Intel[®] Pentium[®] III Xeon[™] Processor Specification Update

Release Date: August 2000

Order Number: 244460-019

The Pentium[®] III Xeon processor may contain design defects or errors known as errata which may cause the product to deviate from published specifications. Current characterized errata are documented in this Specification Update.

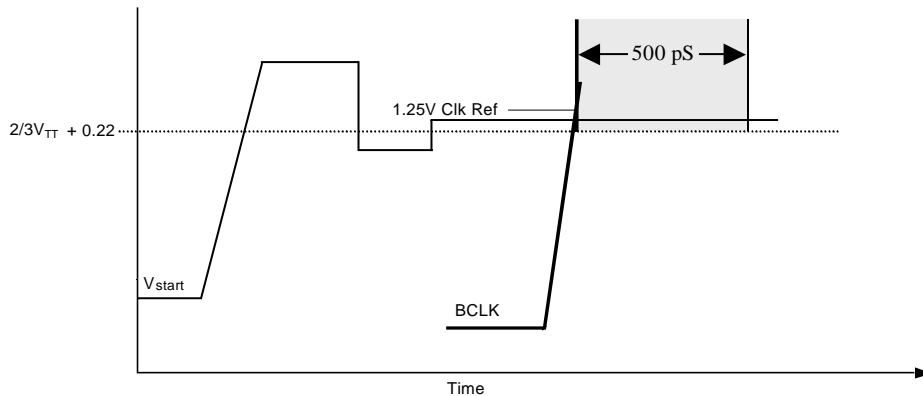
Software using unsynchronized XMC to modify the instruction byte stream of a processor can see unexpected instruction execution from the processor that is executing the modified code.

Implication: In this case, the phrase "unexpected execution behavior" encompasses the generation of most of the exceptions listed in the *Intel Architecture Software Developer's Manual Volume 3: System Programming Guide* including a General Protection Fault (GPF). In the event of a GPF the application executing the unsynchronized XMC operation would be terminated by the operating system.

Workaround: In order to avoid this erratum, programmers should use the XMC synchronization algorithm as detailed in the *Intel Architecture Software Developer's Manual Volume 3: System Programming Guide*, Section 7.1.3.

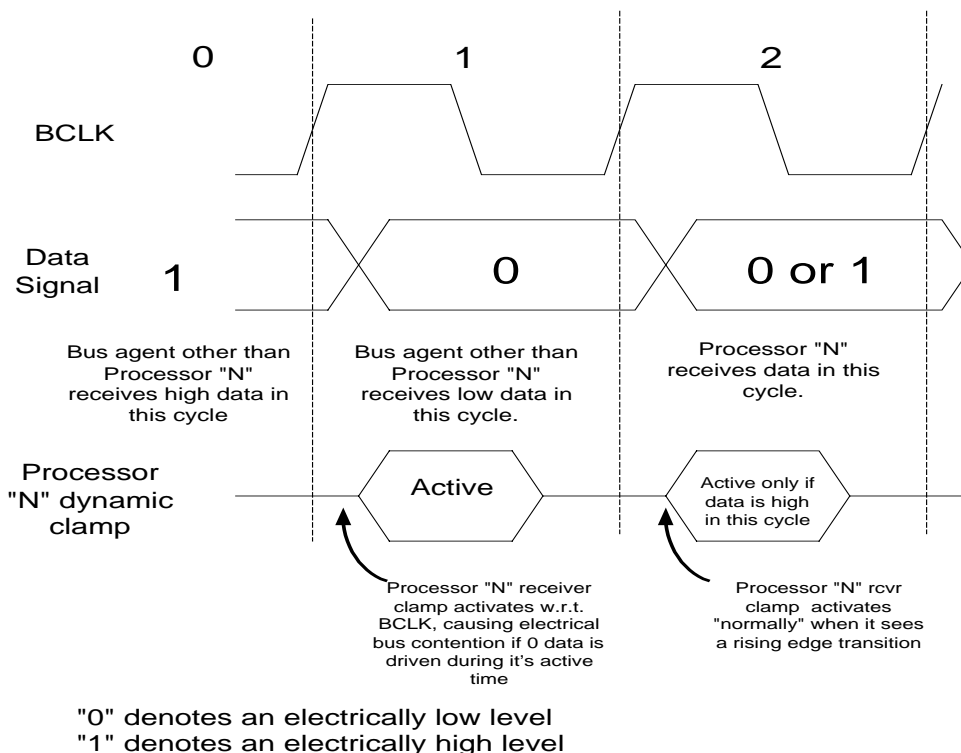
Workaround: The AGTL+ V_{REF} (input voltage reference) level will be raised from 1.0V to 1.1V (assuming a V_{TT} of 1.5V) on the processor cartridge substrate. This allows the dynamic clamp to activate at a trigger level approximately 100 mV higher than with the previous 1.0V V_{REF} setting. Due to the dependence upon system bus design, bus layout may be evaluated to determine the need for improvements in falling edge ringback levels. This may involve one or several of the following baseboard modifications:

1. Change termination resistor value to reduce multi-bit noise and/or improve V_{IL} noise margin.
2. Reduce multi-bit noise by improving ground return paths (additional high-frequency decoupling, improved AC plane referencing, etc.).
3. Raising or lowering the V_{TT} level (within the AC & DC tolerances specified in the processor EMTS) to improve V_{IL} noise margin and/or reduce the multi-bit noise due to dl/dt transients.

Stress tests using various data patterns and transactions should be run to identify the worst-case multi-bit noise conditions for this erratum.
